New MSI LVDT for HallScrew Compressors

From the 1st February 2008, all compressors from the factory in Italy will be supplied with the MSI (Schaevitz) LVDT which replaces the HBLVDT previously fitted.

Table 1 MSI LVDT/HBLVDT Part Number Cross-reference

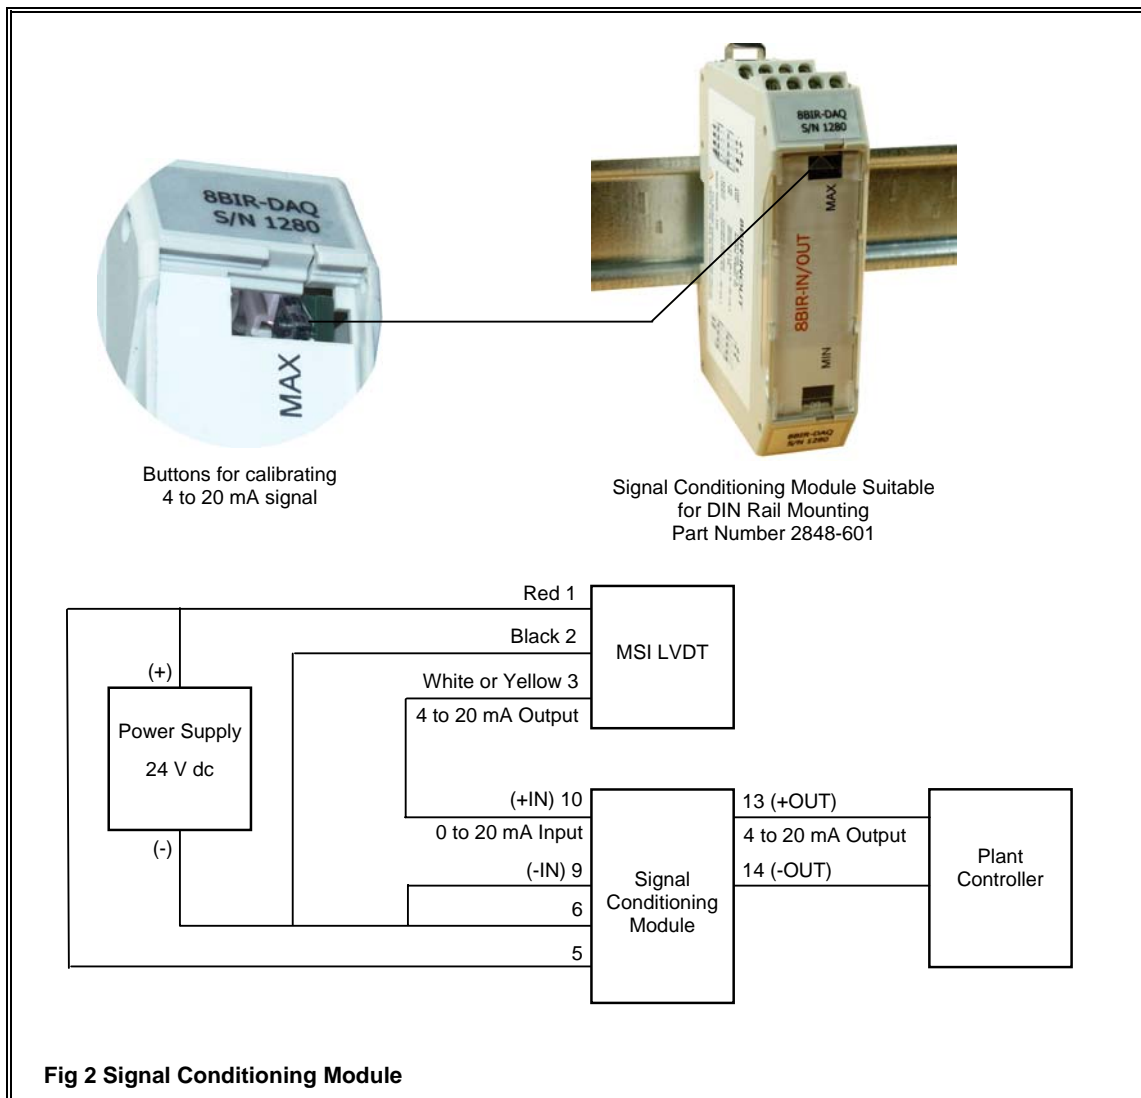
- The MSI LVDT is a drop-in replacement for the HBLVDT. Adaptors, spacers etc., are not required; refer to Table 1.
- The MSI LVDT is only available without calibration, this must be done on the controller. However, a signal conditioning module is available, part number 2848-601, for applications where this is not possible. The module is suitable for DIN rail mounting; refer to Fig 2.

¹ J & E Hall Part Number		HallScrew Compressor Series	
MSI LVDT	HBLVDT		
7876-141	7876-111	HS 3100 and HS 3200	
7876-142	7876-112	HS 4200	
7876-143	7876-120	HS 2024	HS 2000
7876-144	7876-121	HS 2028	
7876-145	7876-122	HS 2031	
7876-146	7876-123	HS 2035
